REMARKS

On page 2 of the Office action, the Examiner indicates that the title of the invention is not descriptive. In response, applicants have amended the title herein to read as follows:

**IMAGING APPARATUS AND METHOD OF ASSEMBLING**

FIG. 1

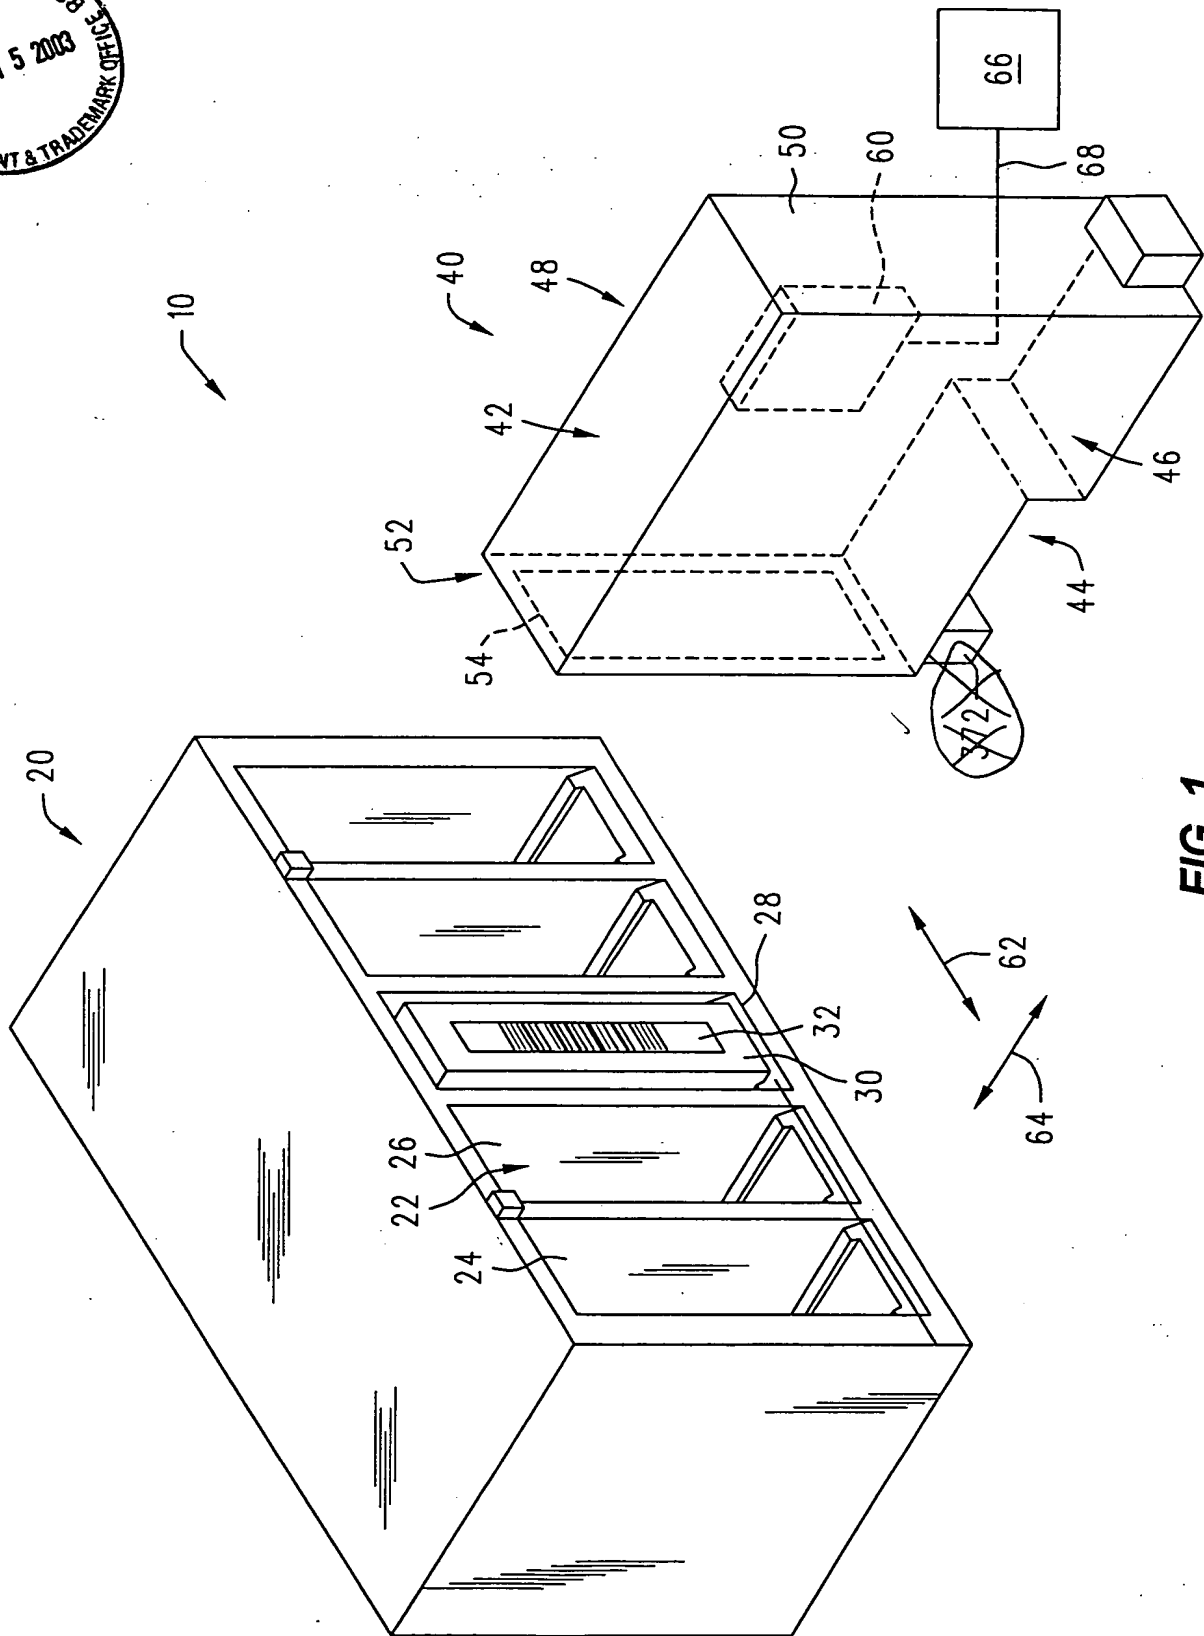
The Examiner notes that there is no mention in the written description of reference numeral 372 (appearing in Fig. 1). In response, applicants have amended Fig. 1 to remove reference numeral 372.

FIG. 4

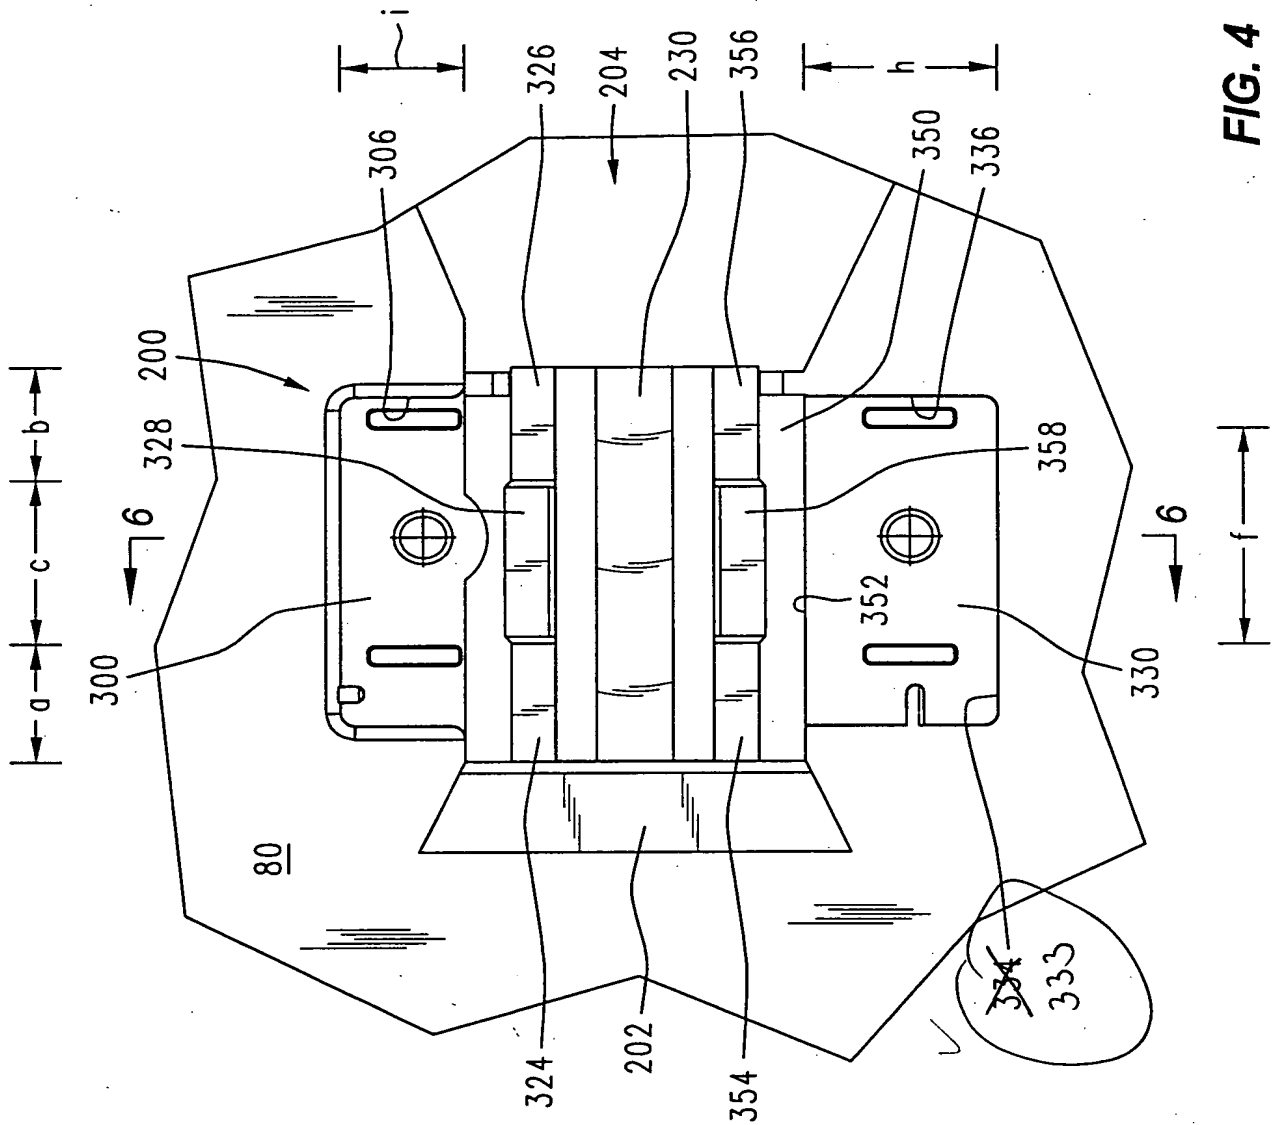
The Examiner points out that reference numeral 334 is used to refer to both the second sidewall in Fig. 4 and a hole in Figs. 3 and 6. In response, applicants have amended the specification and drawings such that reference numeral 334 refers to the hole and new reference numeral 333 refers to the second sidewall. Specifically, Fig. 4 has been amended to change the

sidewall designation "334" to new reference numeral "333". The specification has been amended at page 13, line 12 to change "second sidewall 334" to now read "second sidewall 333".

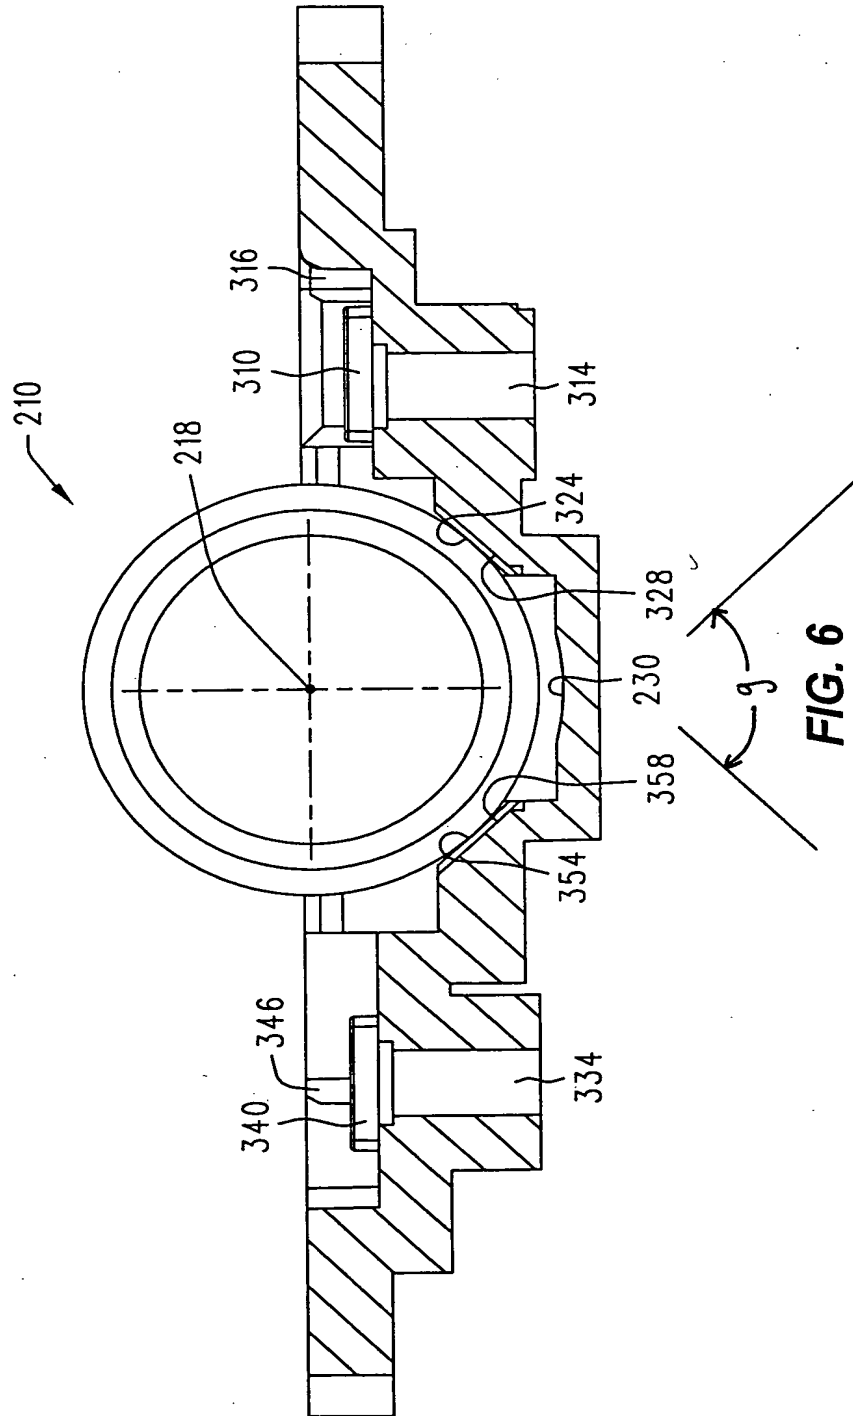
The Examiner questions whether the angle "g" was intended to be shown in Fig. 6. In response, applicants have amended Fig. 6 to add the angle "g".

**FIG. 8**

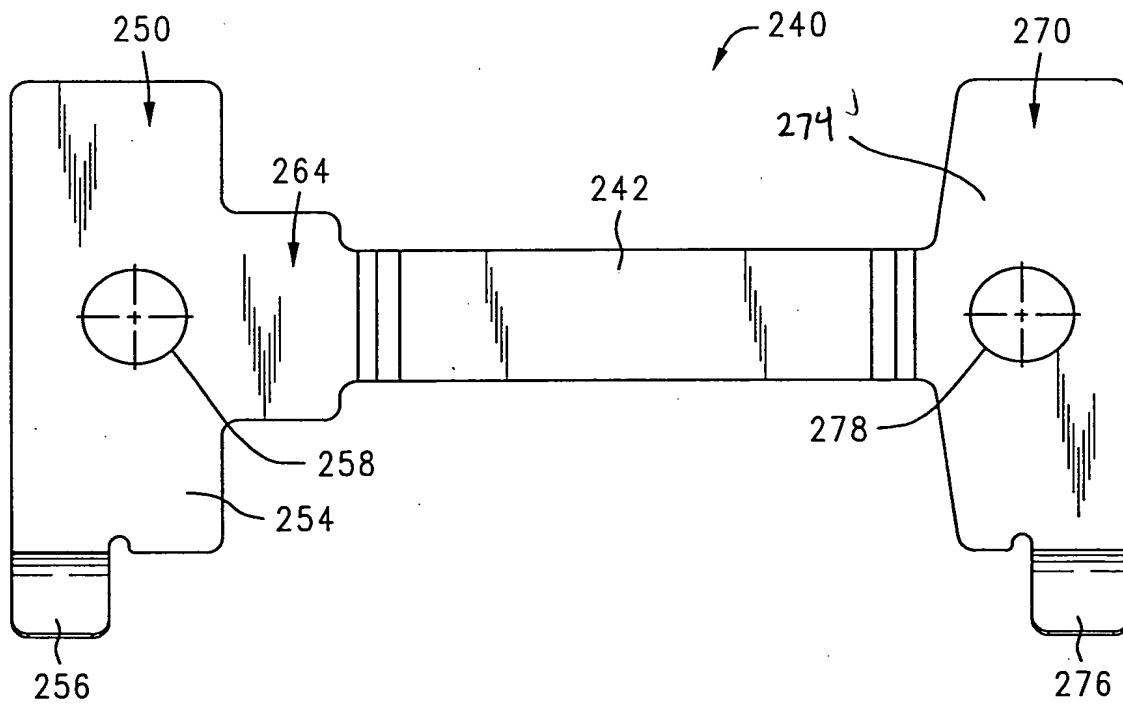
The Examiner notes that the reference numeral "274" is not shown in Fig. 8. In response, applicants have amended Fig. 8 to add reference numeral 274.

**FIG. 9**

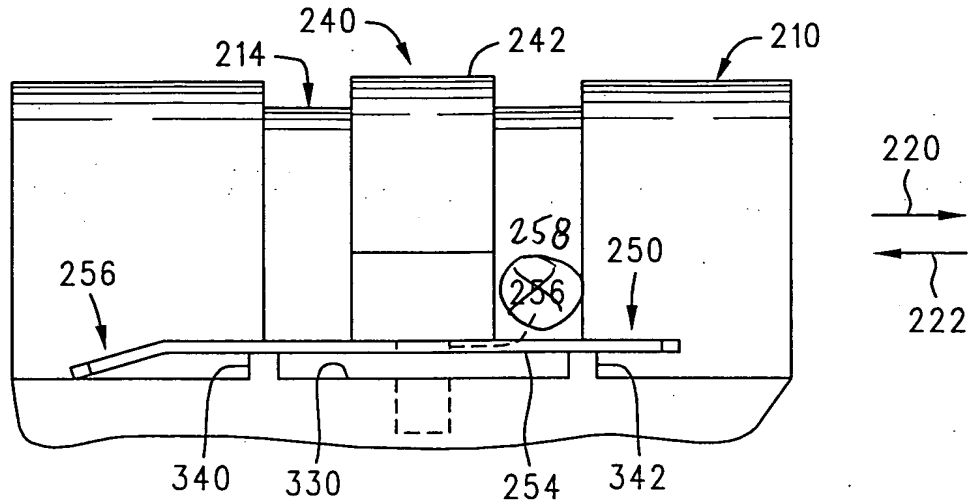
Applicants have also amended Fig. 9 herein to correct a minor error appearing therein. Specifically, the reference numeral "256" denotes two features in the drawing. Fig. 9 has been amended to denote the hole with reference numeral "258" instead of "256"
